HISTORIC AND DESIGN REVIEW COMMISSION

HDRC CASE NO: 2024-079
ADDRESS: 2218 ORR DR
LEGAL DESCRIPTION: NCB 16524 BLK 14 LOT 10 & 11
ZONING: R-6
CITY COUNCIL DIST.: 6
DISTRICT: Public Property
APPLICANT: Alaina B Parker | MP Studio Landscape Architecture LLC
OWNER: Arthur M Rossman | COSA
TYPE OF WORK: Park construction
APPLICATION RECEIVED: February 16, 2024
60-DAY REVIEW: April 16, 2024
CASE MANAGER: Bryan Morales

The applicant is requesting a Certificate of Appropriateness for approval to construct a new park at 2218 Orr Dr.

**75% CD
REVIEW SET**

OVERALL SITE PLAN

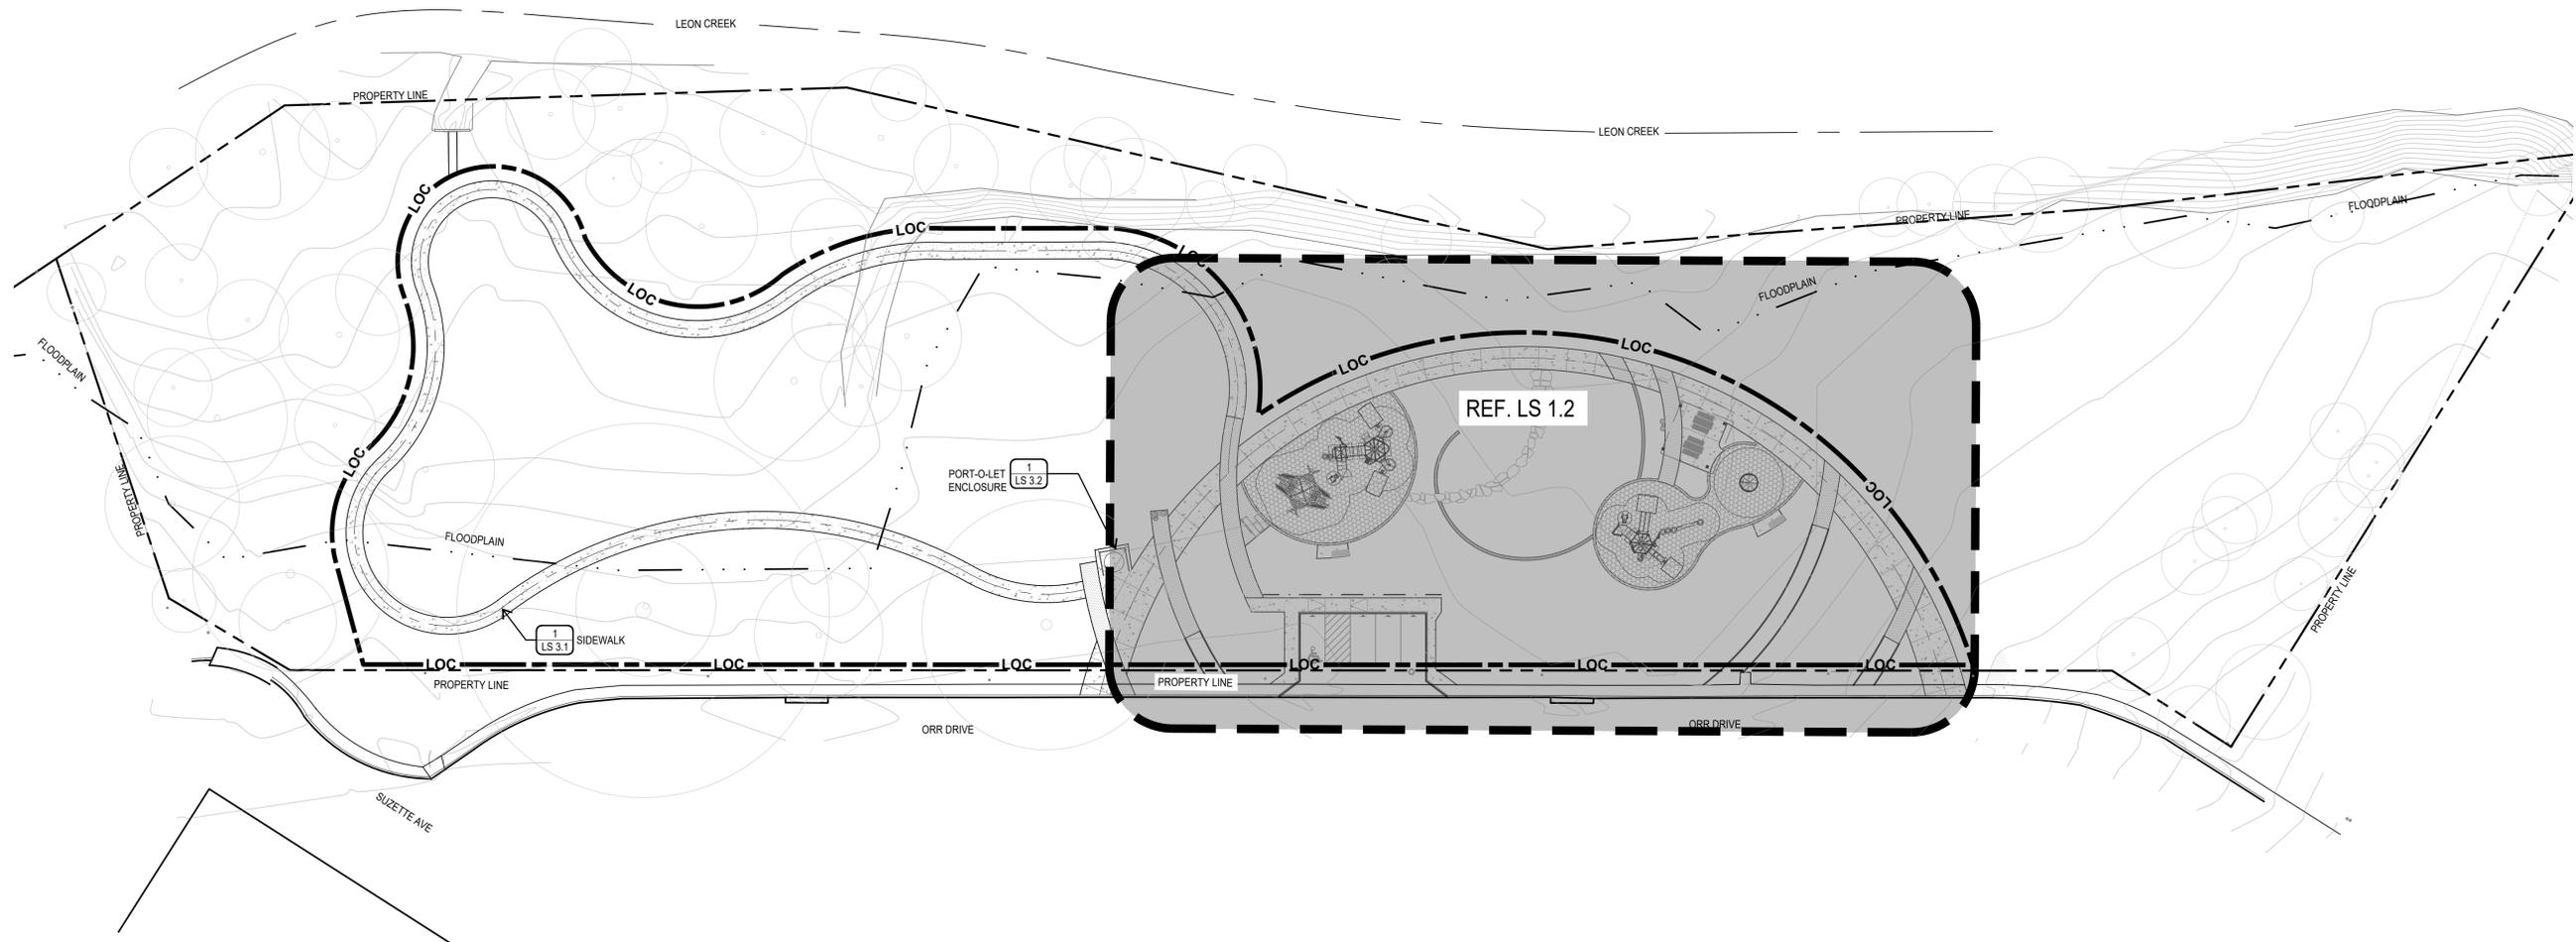
- b. PARK AMENITIES – The applicant is requesting approval to construct a park with the following amenities: concrete sidewalks, two playgrounds, a port-o-let restroom enclosure, off-street parking spaces with an ADA parking stall, a water drinking fountain, a shade structure picnic area, a small children's stage, and a walking concrete loop trail. Staff finds the proposal generally consistent with UDC Sec. 35-642.

- d. WALKWAYS – The applicant has proposed to install a multi-use trail with lighting throughout the proposed park, ADA accessible sidewalks, and a 4-parking space parking lot. UDC Sec. 35-642(b)(8) states that the site should take into account the compatibility of landscaping, parking facilities, utility and service areas, walkways and appurtenances. These should be designed with the overall environment in mind and should be in visual keeping with related buildings, structures and places. Staff finds the proposal generally consistent with the UDC Sec. 35-642.

Staff recommends approval of the proposal to develop Cable Westwood Park as a new public park based on findings a through f with the following stipulation:

3 SINGLE TOILET ENCLOSURE
ELEVATION SCALE: 1/2"=1'-0"

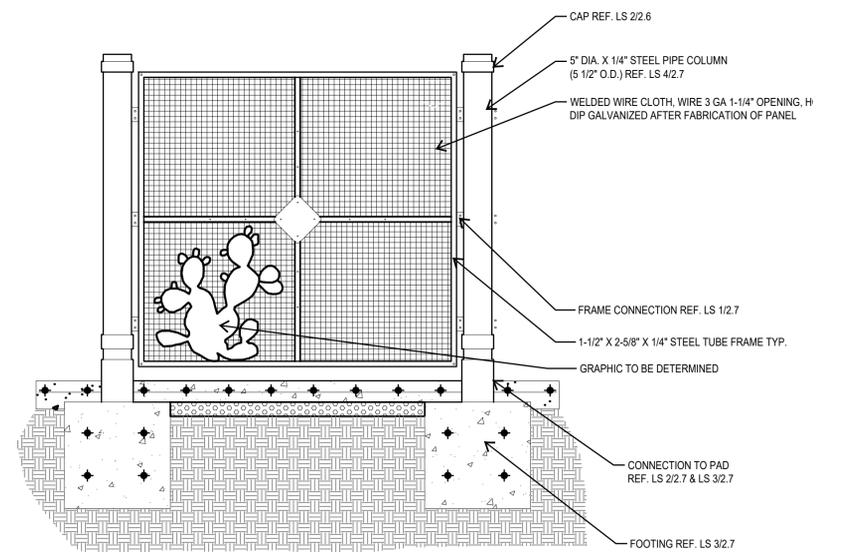
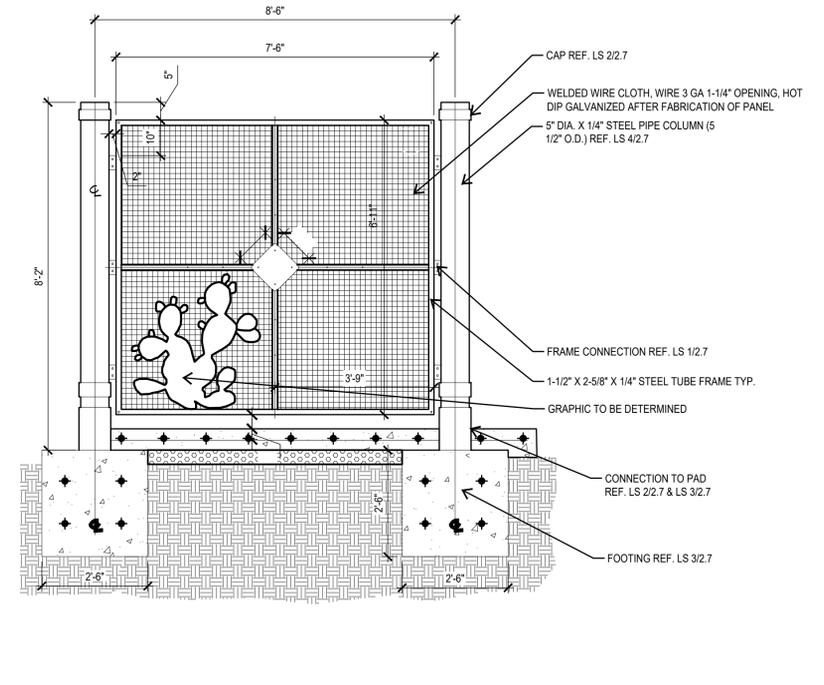
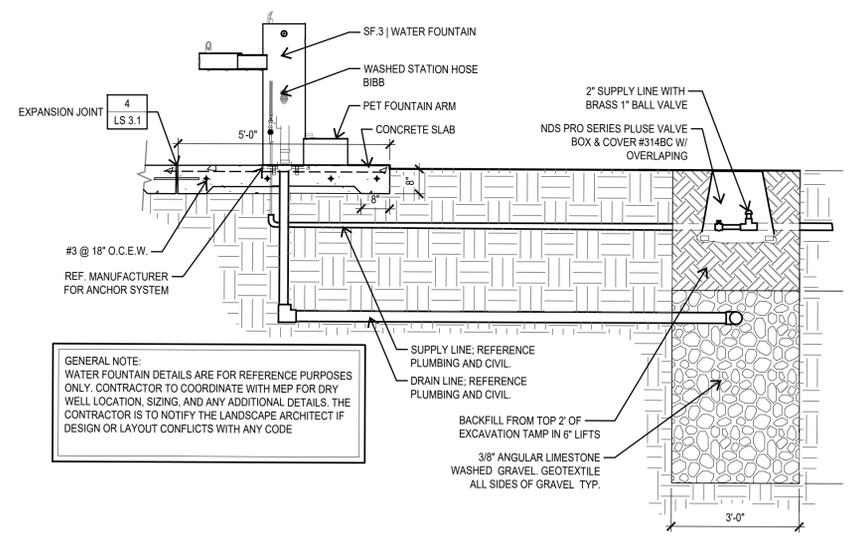
- c. RESTROOM FACILITY – The applicant is requesting approval to construct a port-o-let restroom enclosure. Staff finds the proposed port-o-let restroom enclosure consistent with the UDC.

5 WOOD FENCE
SIDE SECTION
SCALE: 1"=1'-0"

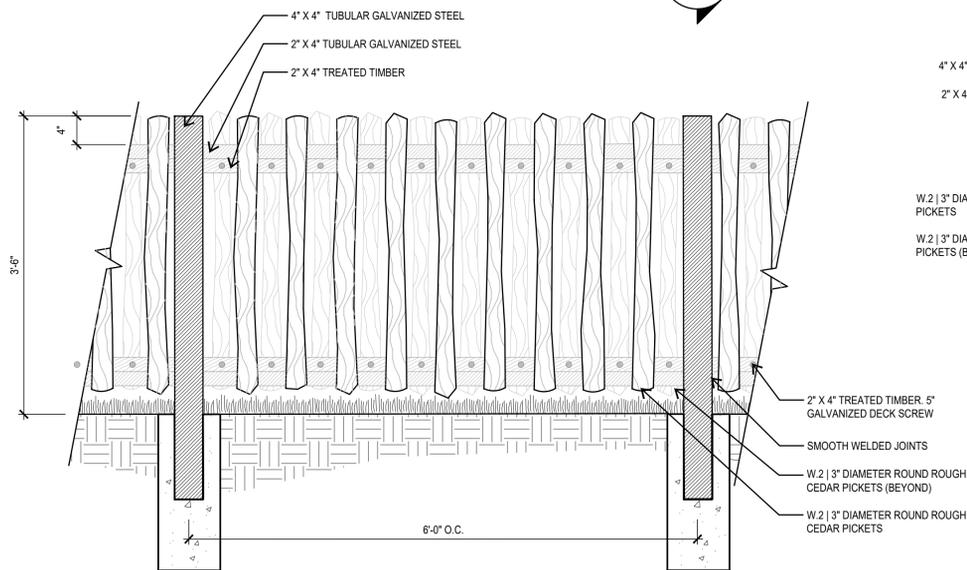
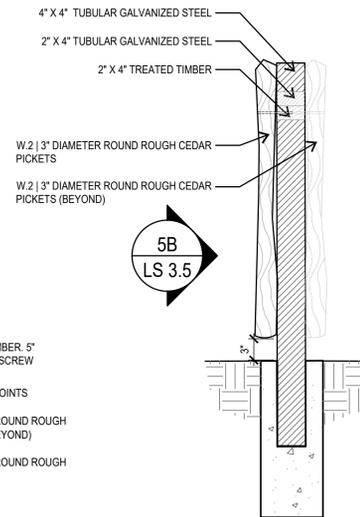
- e. FENCING – The applicant has proposed to install four feet tall alternating wood picket fencing with square steel posts to run parallel along the walkway plan north of the proposed parking spots. Staff finds the proposal generally consistent with the UDC.
